**Former Chatsworth Mill, Williams Road, Gorton,
Manchester, M18 7AY.**

**Information for the discharge of drainage related planning condition for
Application No: 129852/FO/2021.**

Plate 4-1: Summary of ground conditions.

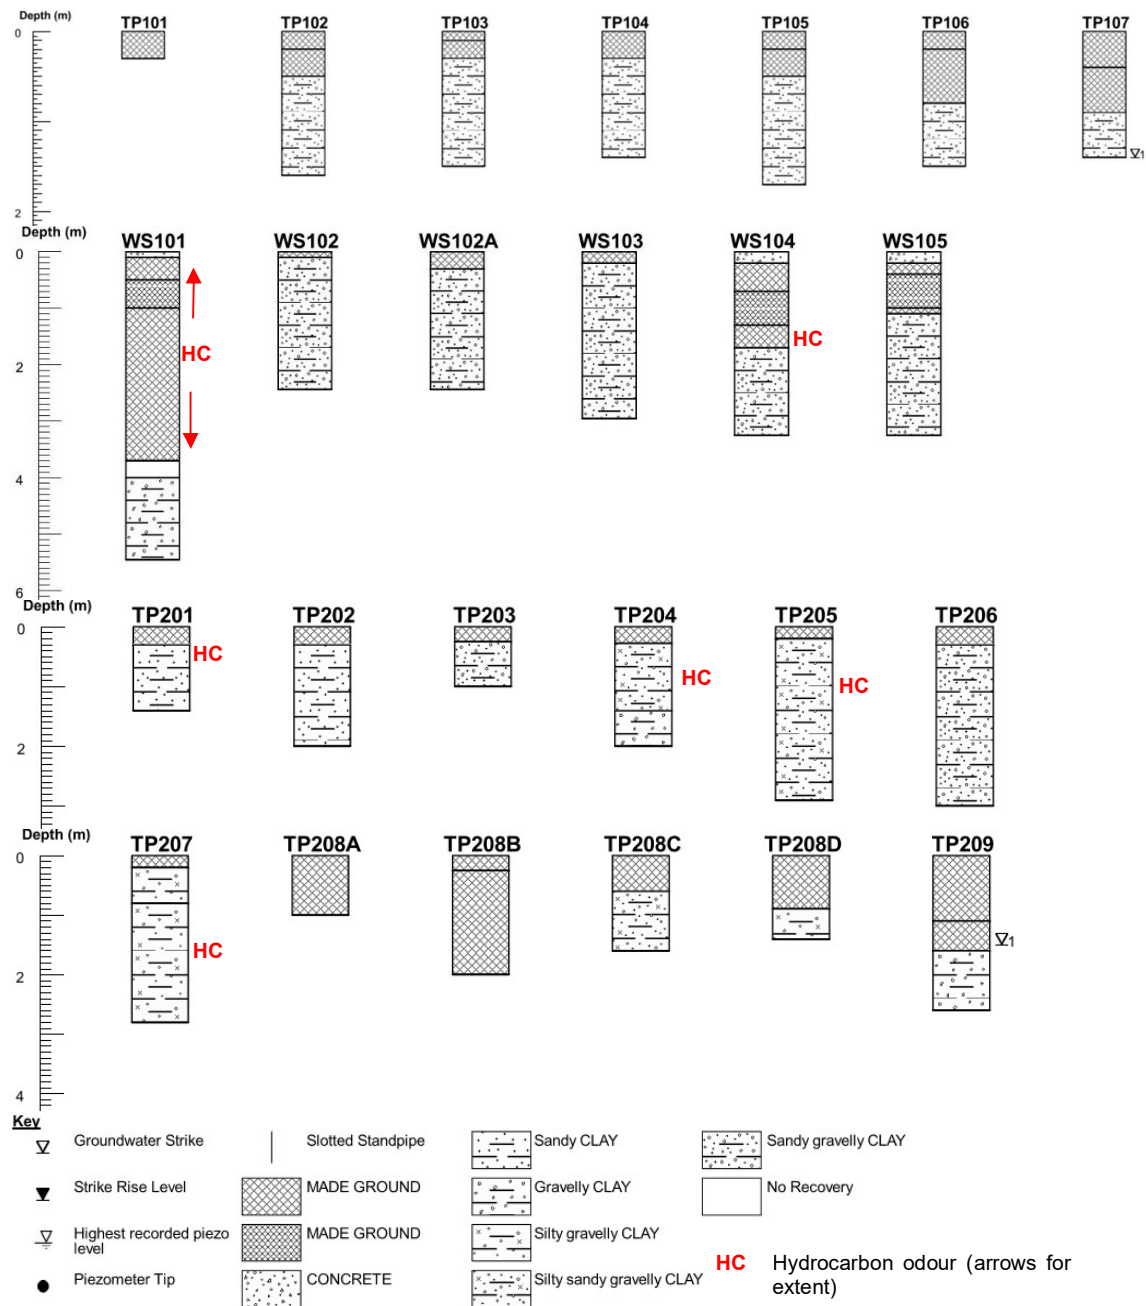
- An updated assessment of alternative green SuDS solution (that is either utilising infiltration or attenuation) if practicable following site investigation works;

The site is not suitable for infiltration. Trial pit data taken from the site investigation report conducted by LK Consult (LKC) identified the presence of made ground over cohesive soils with contamination present. Please see the trial pit data taken from the site investigation report in Appendix 1.

Sewer Map

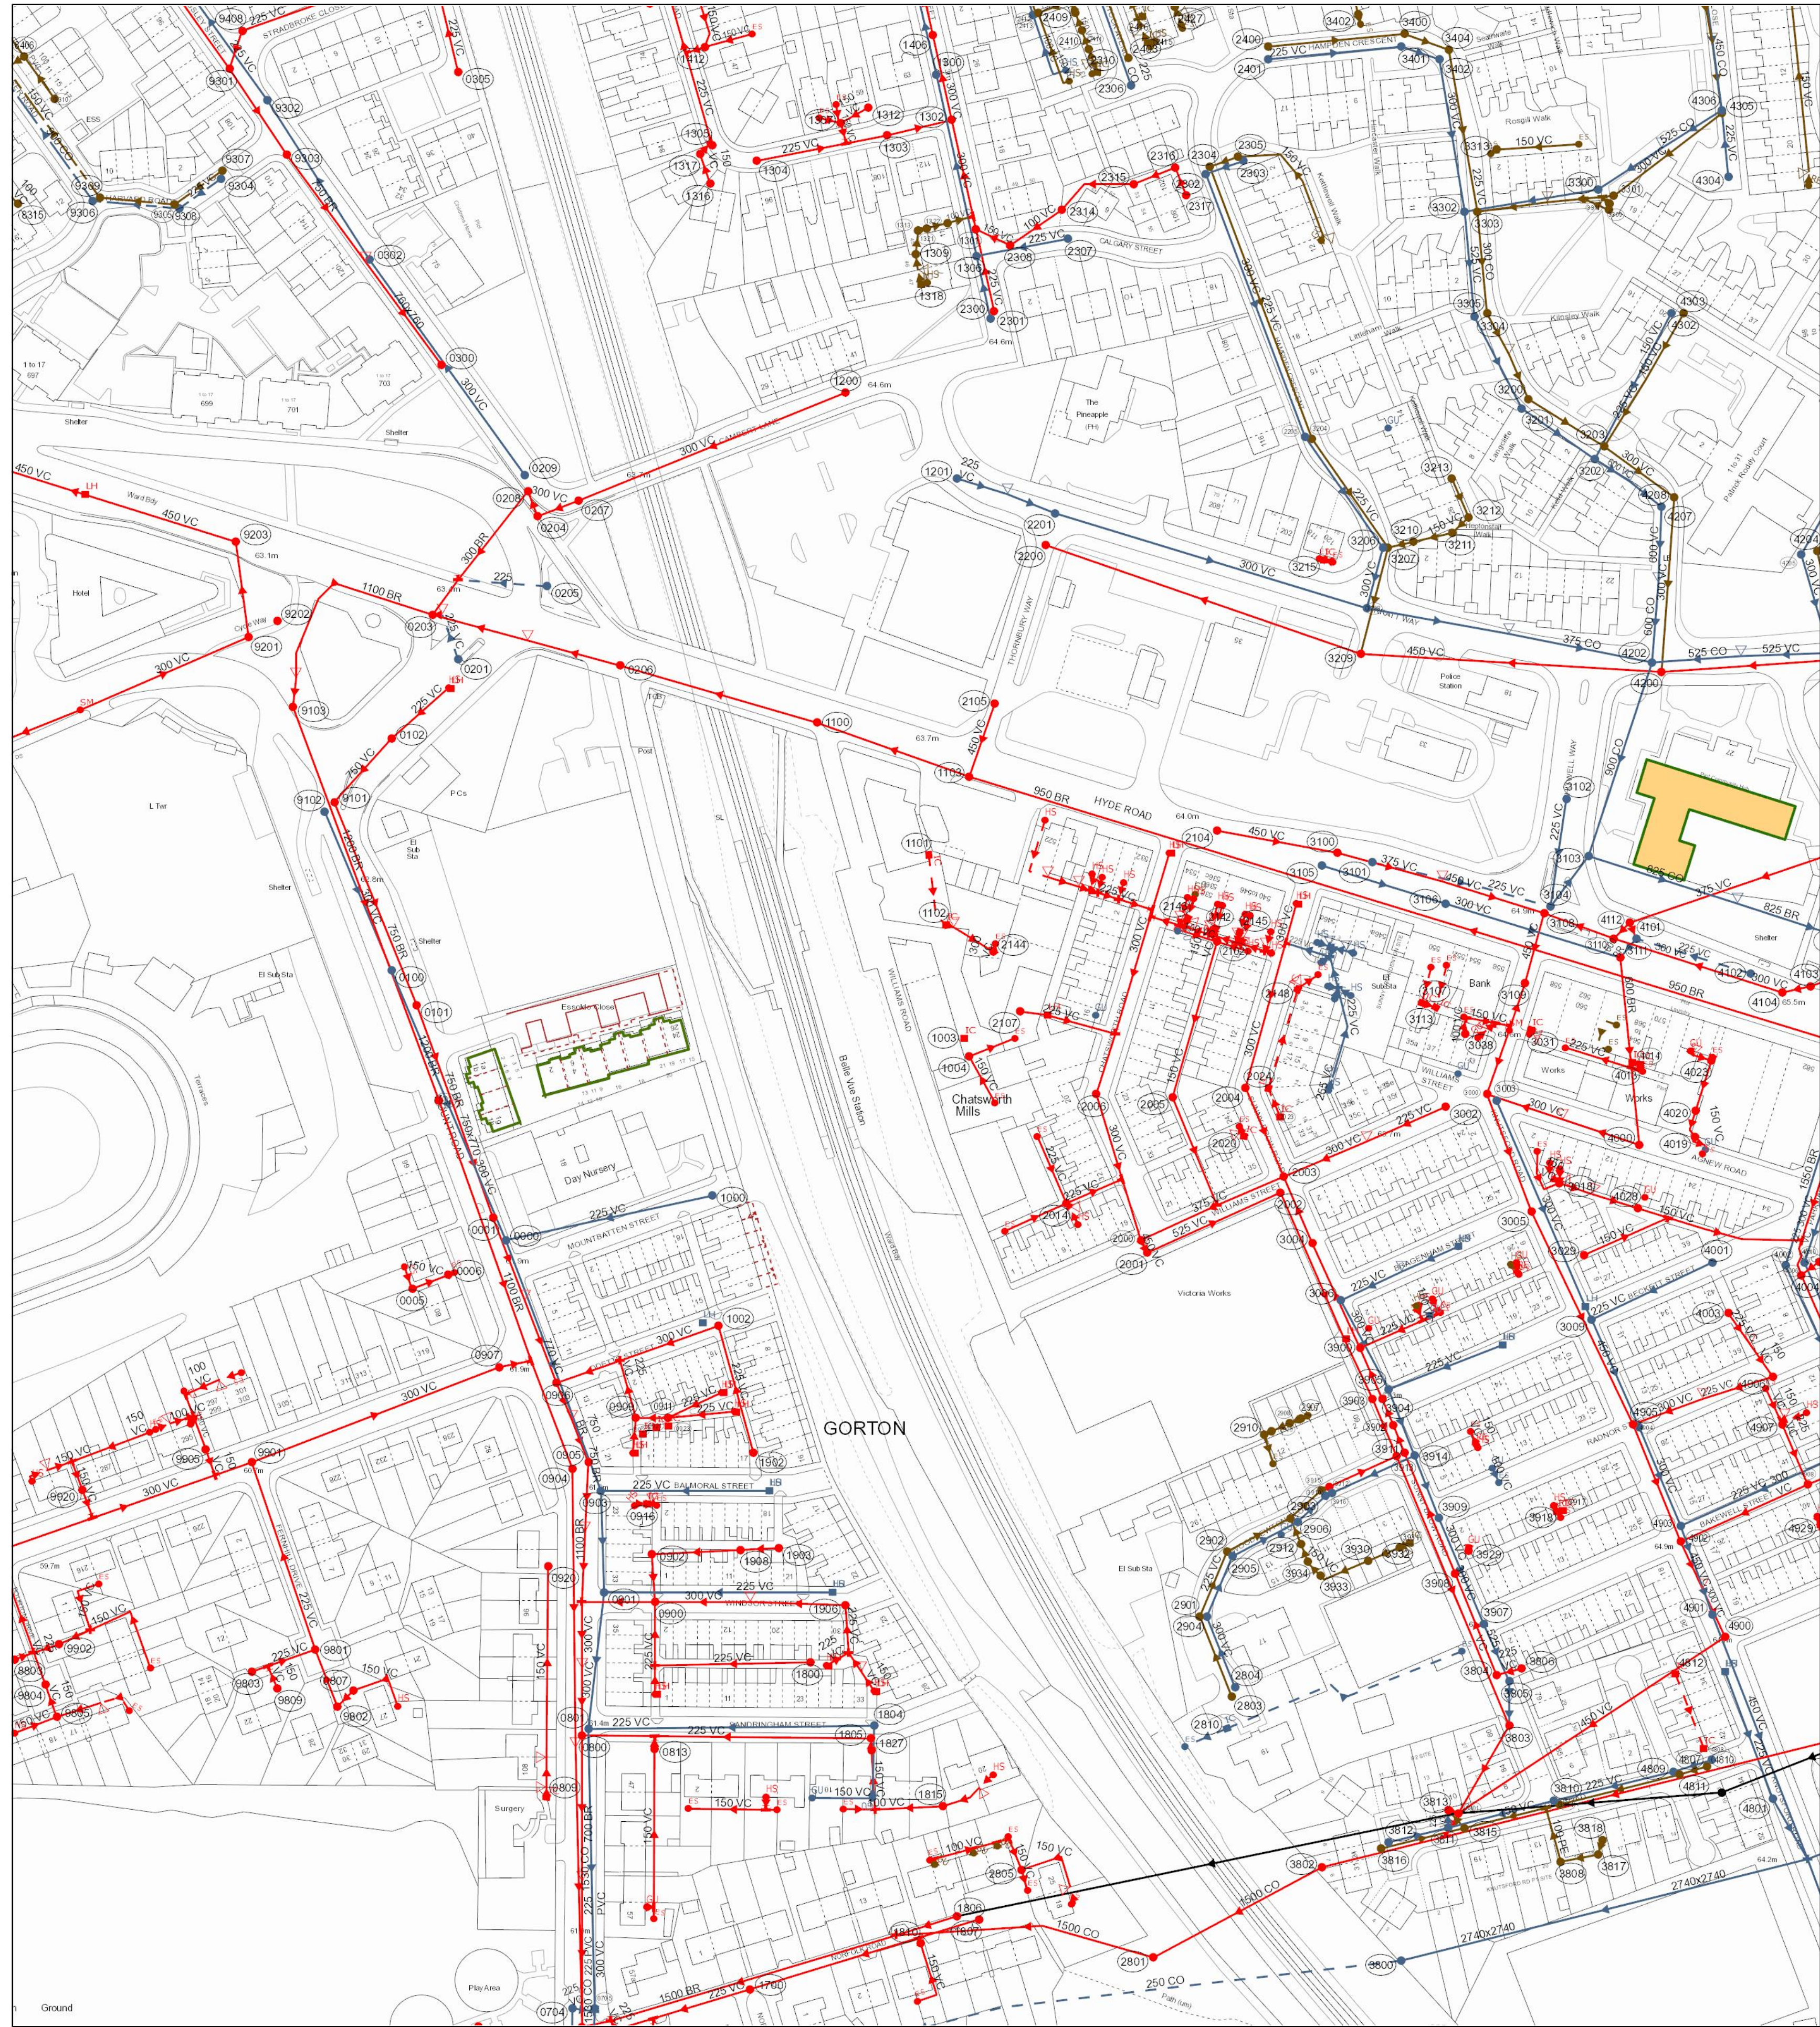
Discharge to Surface Water Sewer

There are no surface water sewers within close vicinity of the site therefore this option can be discounted. Please see the UU sewer map in Appendix 3
